FIELD AND DEPOT MAINTENANCE MANUAL
TEST SETS, ELECTRON TUBE TV-2/U,
TV-2A/U, TV-2B/U, AND TV-2C/U

CHANGE }
No. 1 }

HEADQUARTERS
DEPARTMENT OF THE ARMY
WASHINGTON, D.C., 6 February 1964

TM 11-6625-316-35, 8 September 1961, is changed as follows:

Figure 23. Shunt control test.

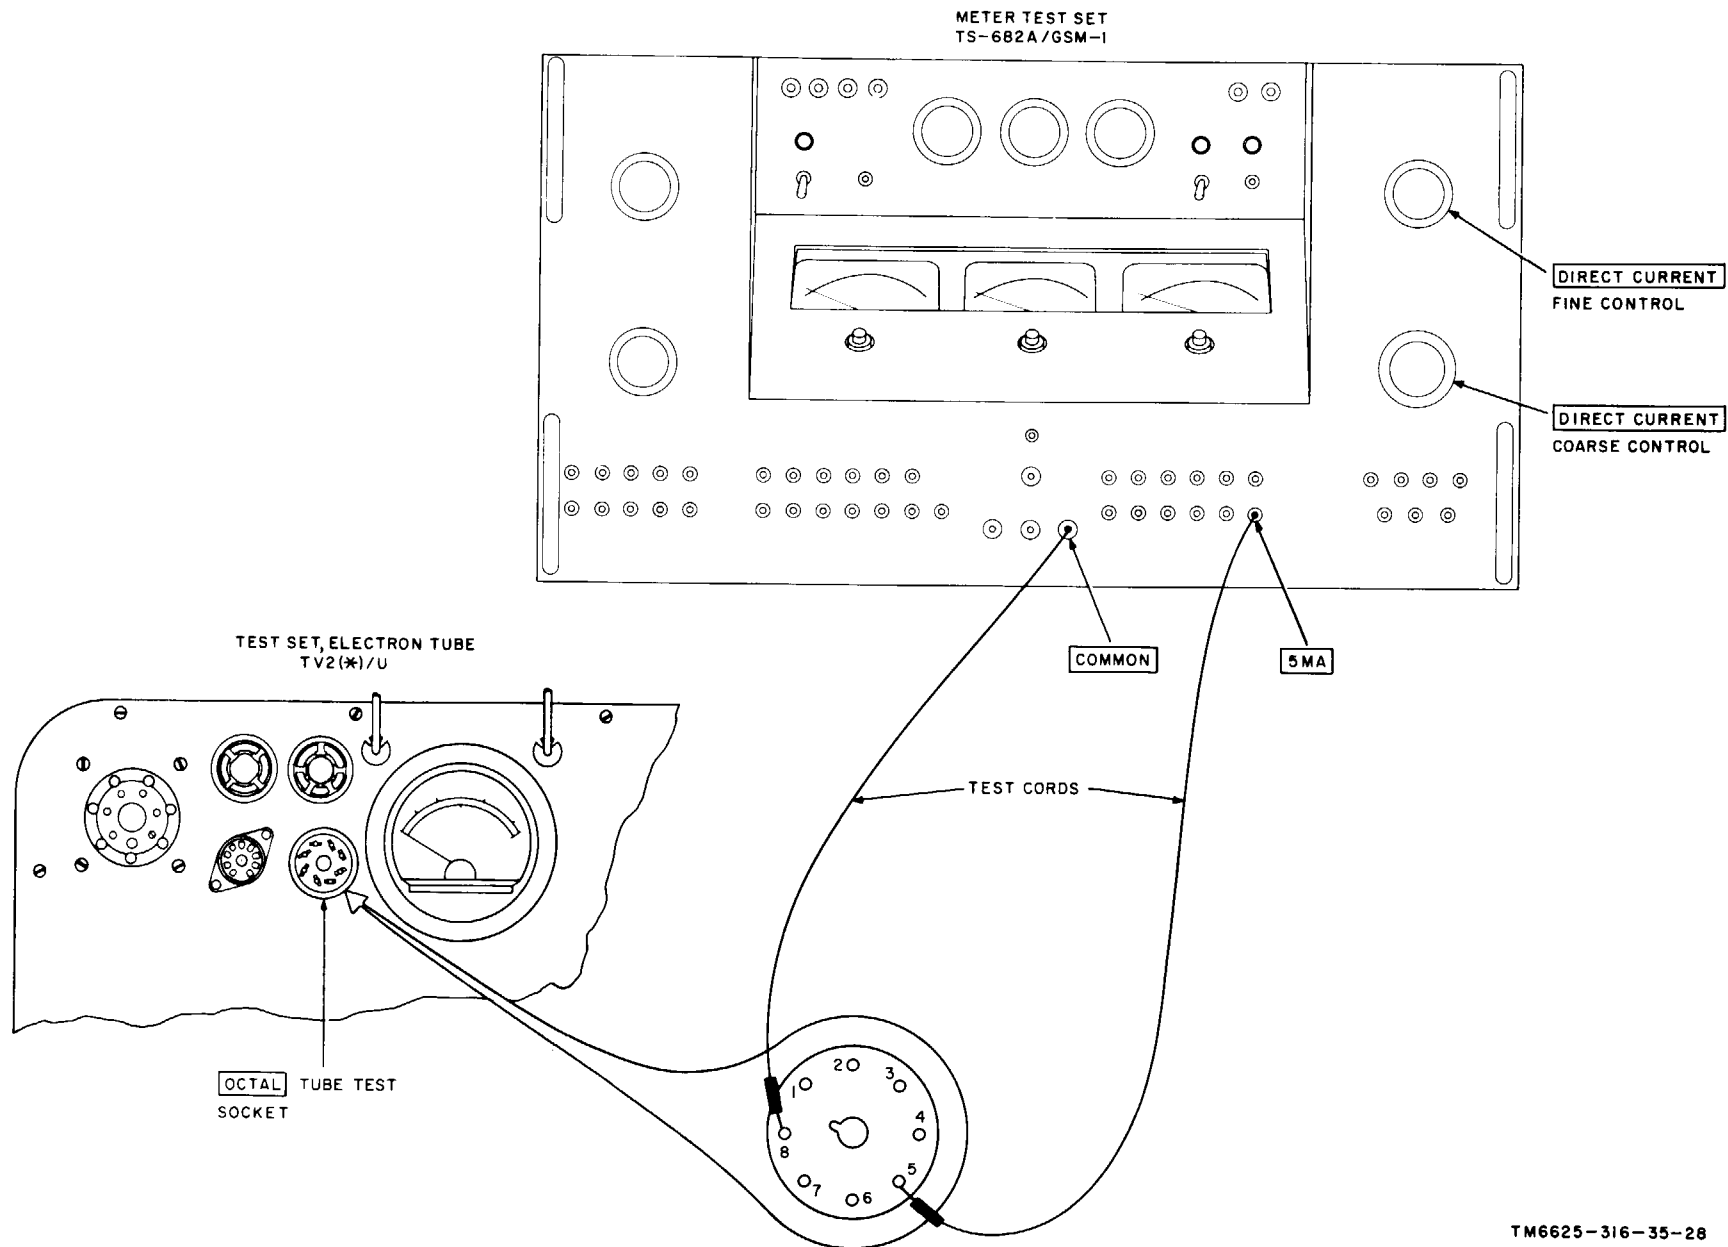
Page 41, figure 23. Change test leads from Meter Test Set TS-682A/GSM-1 to OCTAL tube test socket so that one test lead is from COMMON to pin 5 and one test lead is from 5 MA to pin 8.

Figure 26. Test Set, Electron Tube TV-2(Y)U, schematic diagram.

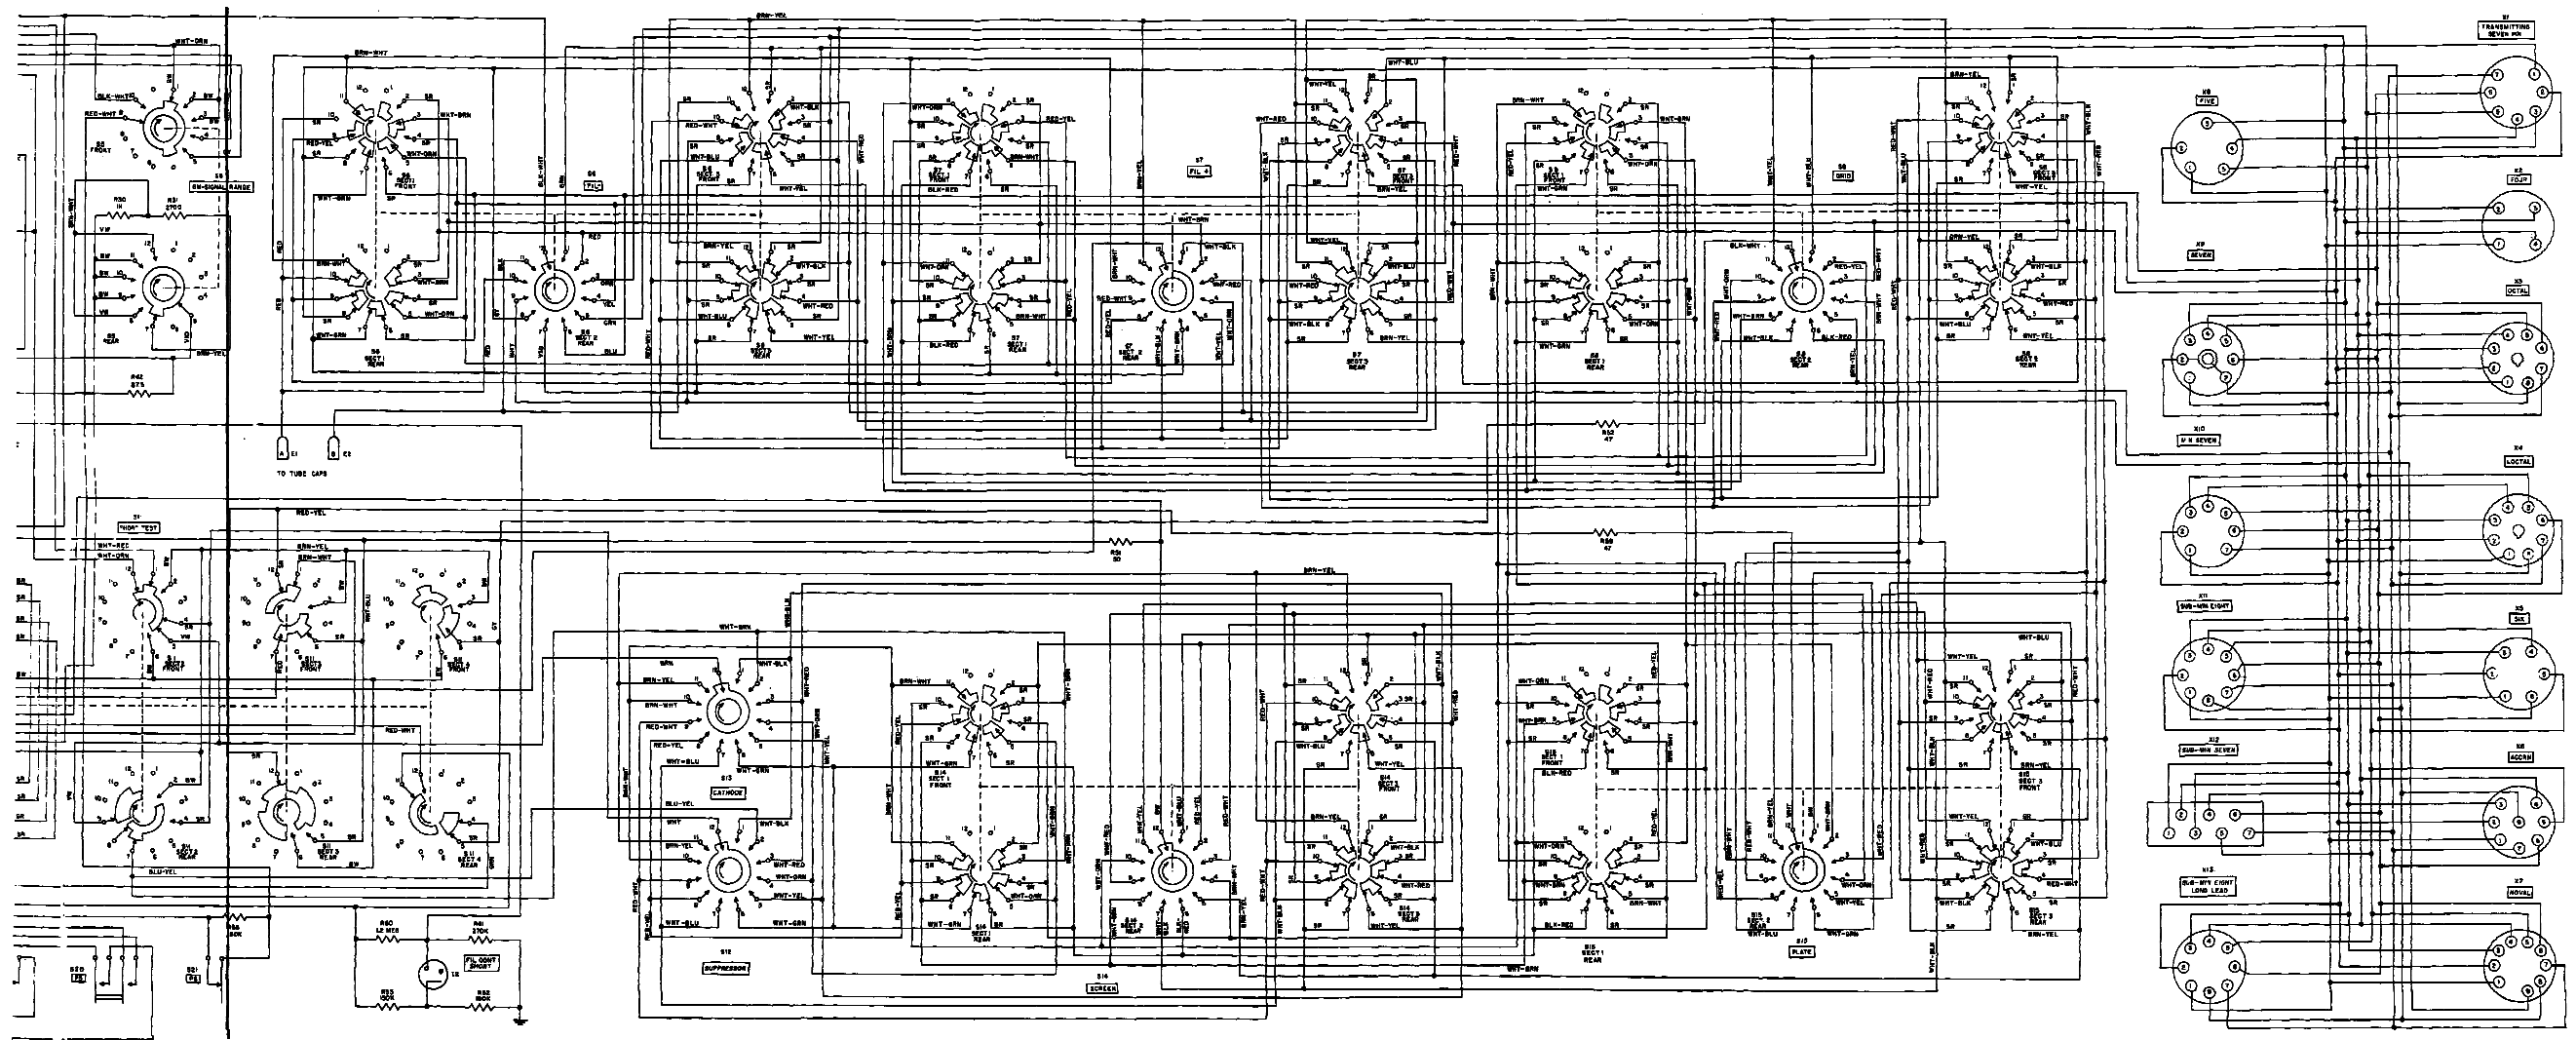
Page 44, figure 26 (Foldout, 1st part). In the top right corner of the illustration, on Switch S2, Section 2, front, add a connection line from Contact 11 to the upper (ungrounded) end of capacitor C 1.
